DESCRIPTIVE REPORT

Field No. BO-2354 Office No. H-8208

General locality Approaches to San Francisco Bay

REVIEW OF HYDROGRAPHIC SURVEY

Chart - 5402

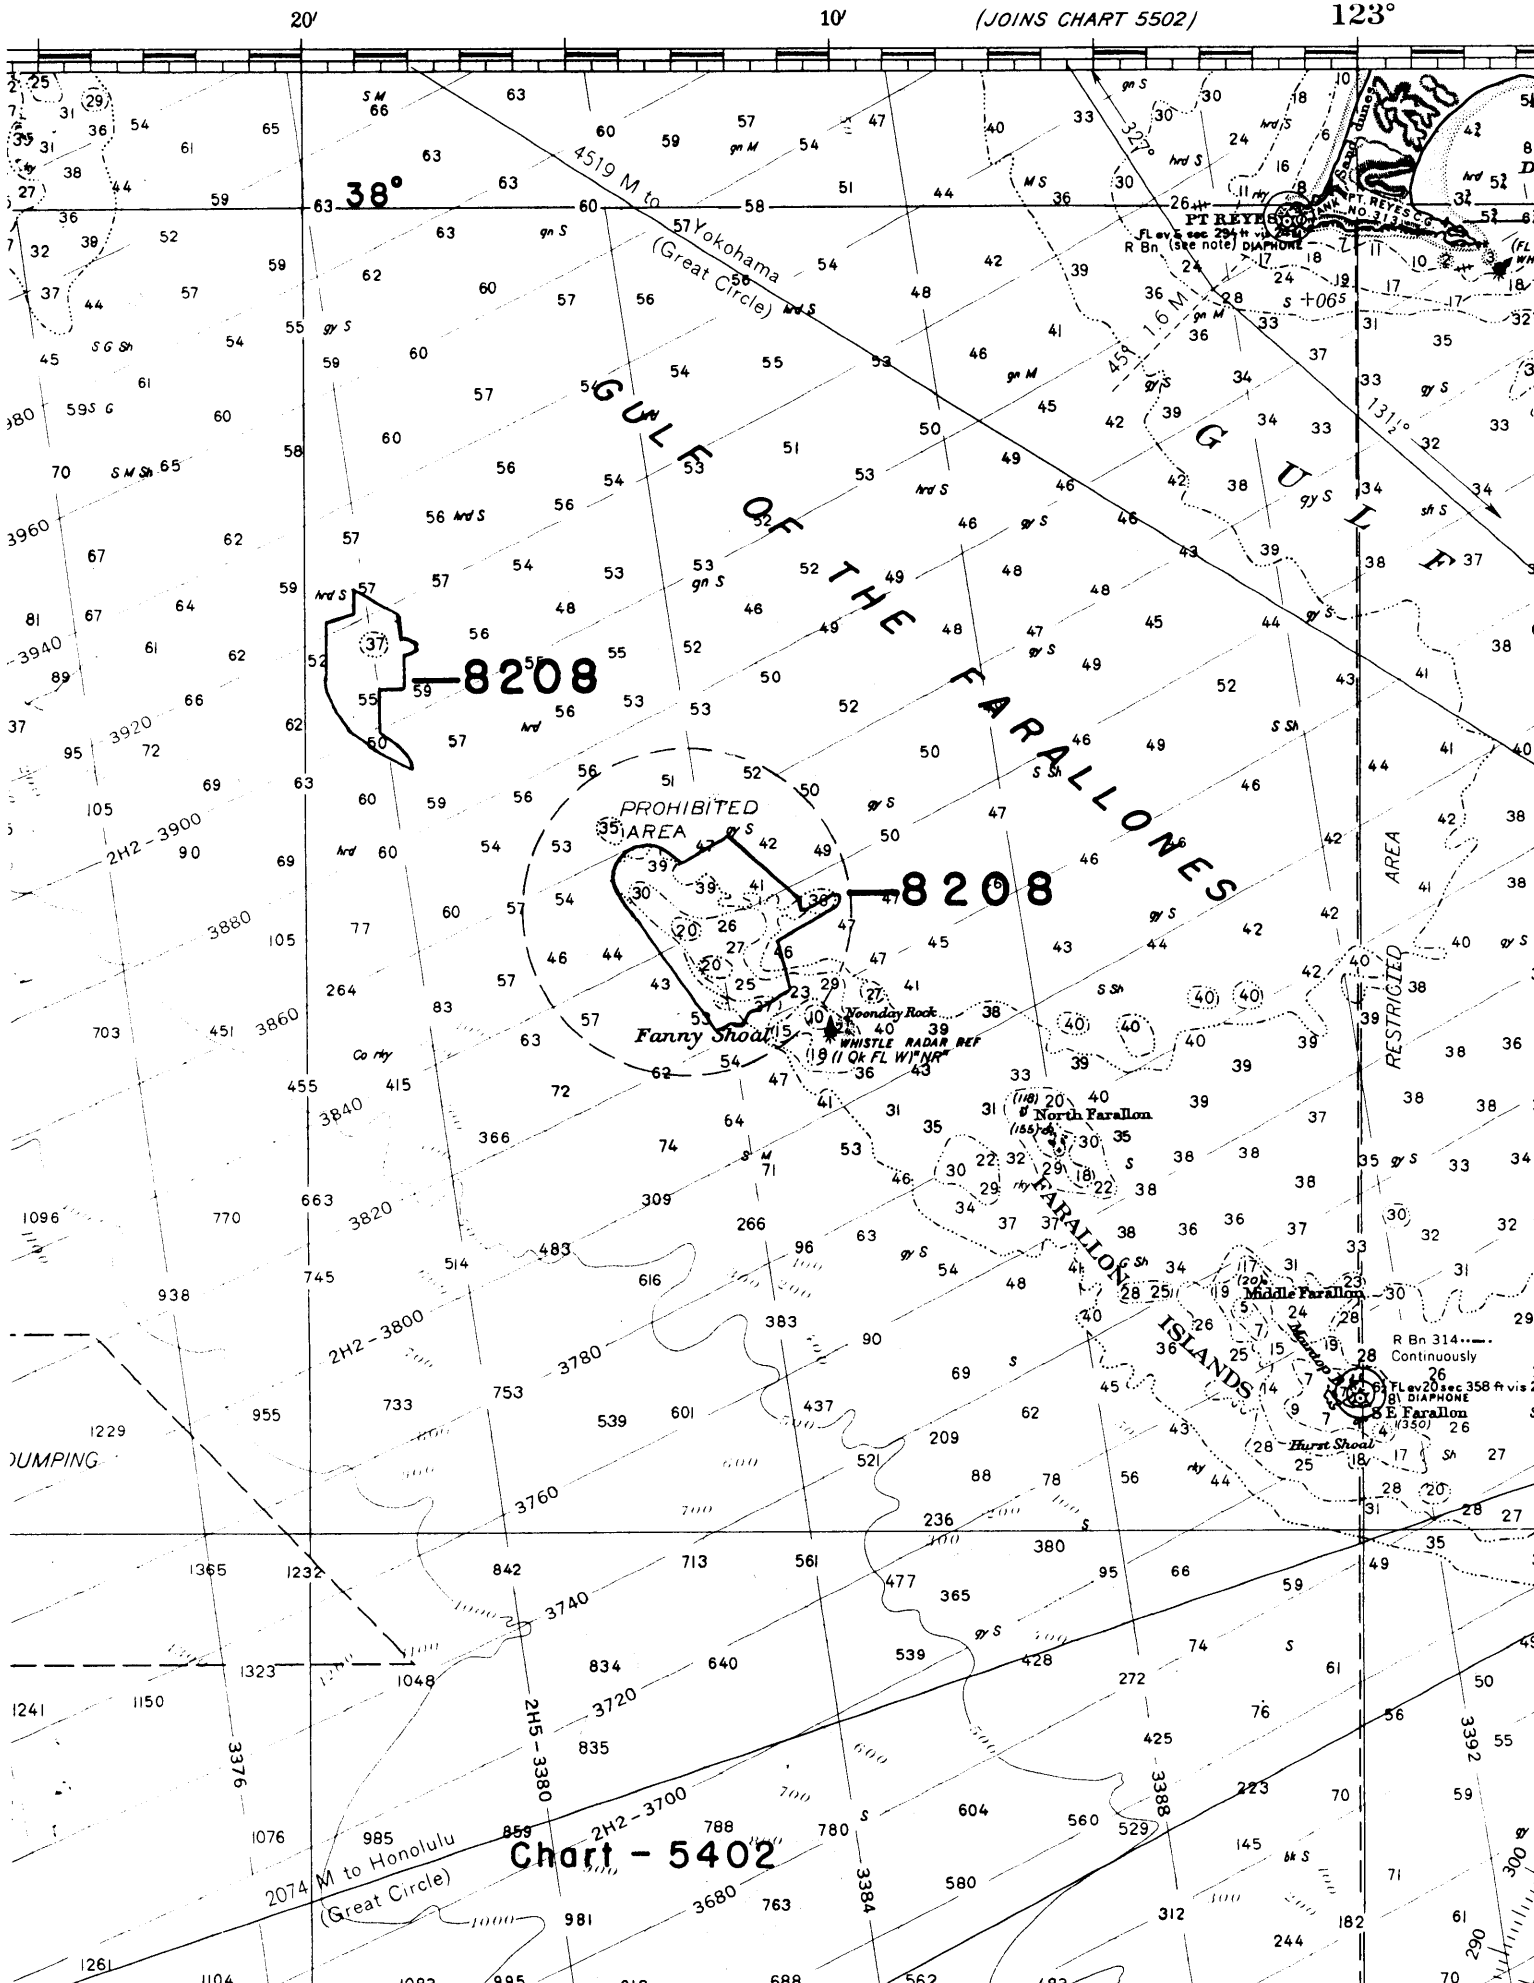
6. Comparison with Chart 5502 (Latest print date 5/7/56)A. Hydrography

Charted hydrography originates principally with the previously discussed survey which needs no further consideration.

The charting of the area covered by the present survey should be governed by the information given in paragraph 5 of this review.
